MODEL: FR600V, FR651V, FR691V, FR730V, FS481V, FS541V, FS651V, FS691V, FS730V, FX481V, FX600V, FX651V, FX691V, FX730V

TITLE: ROCKER ARM CHANGE

FACTORY DIRECTED MODIFICATION

Kit Detail

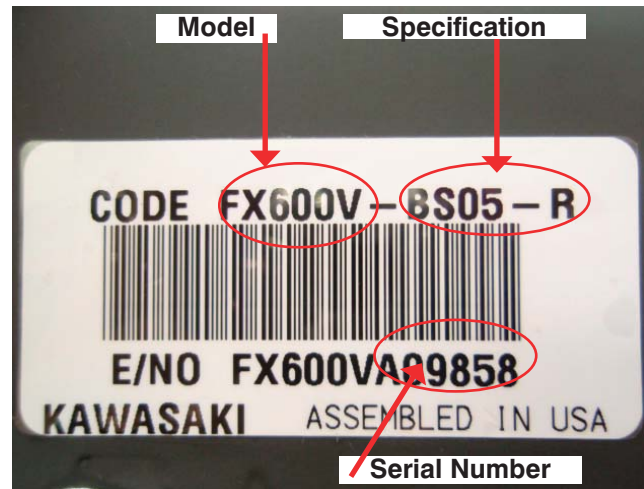
Certain FR, FS, FX, Engine Models may experience rocker arm failure and/or premature wear. Rocker arm and rocker case gasket part kits have been made available to eliminate this possibility during engine operation.

Kawasaki will provide the replacement parts for the repair of all eligible rocker arm and rocker case gaskets. Please order the required kit quantity through the routine parts ordering system.

Item	Part Number	Qty
Arm-Rocker	12016-2066	4
Gasket	11061-7083	2

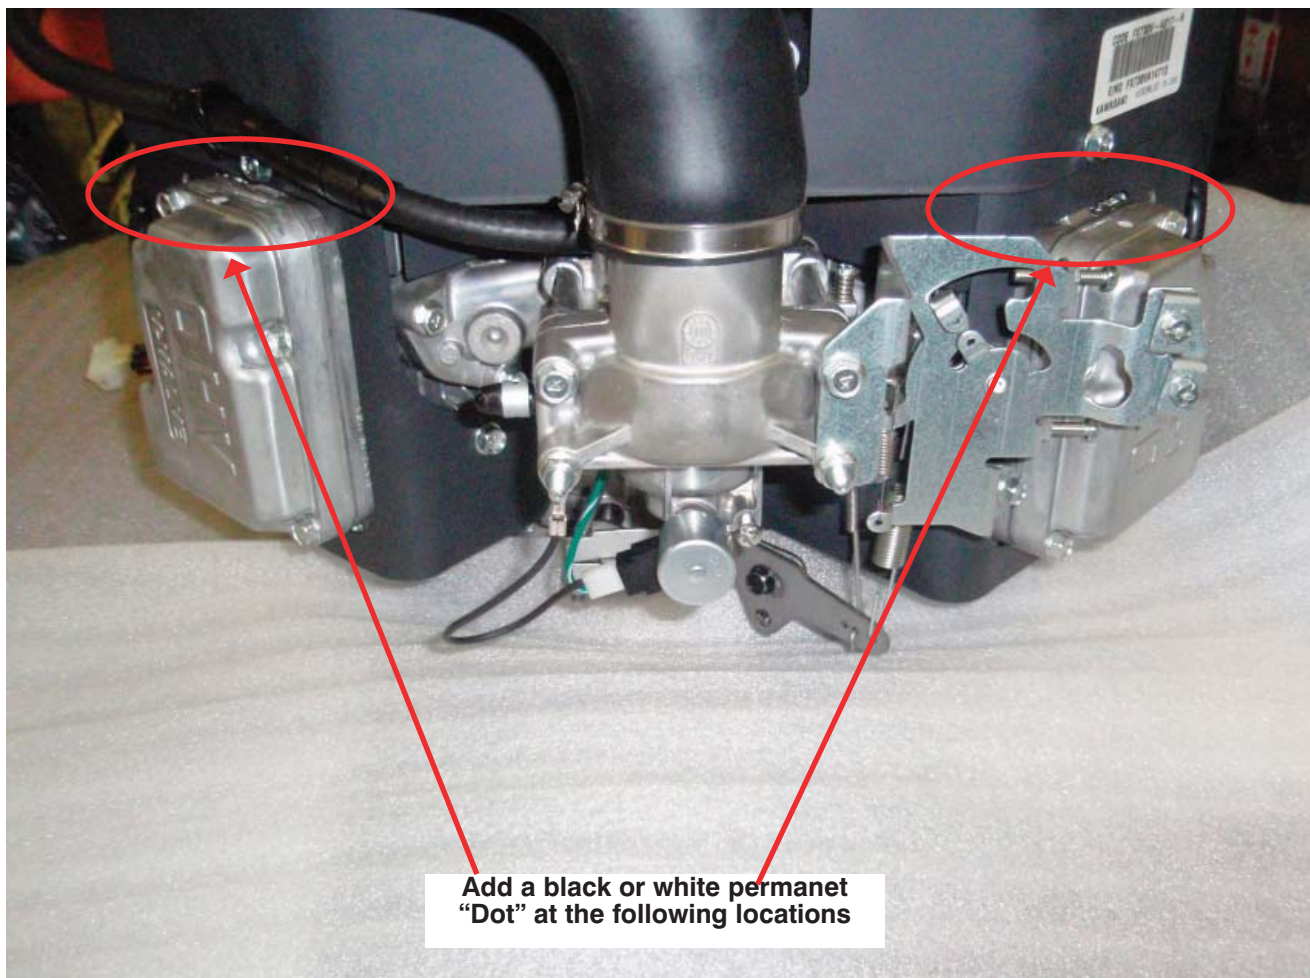
4. As a quick reference to identify that the FDM has been applied, please add a non-fading permanent black or white "Dot" on the top of each rocker case as shown below.
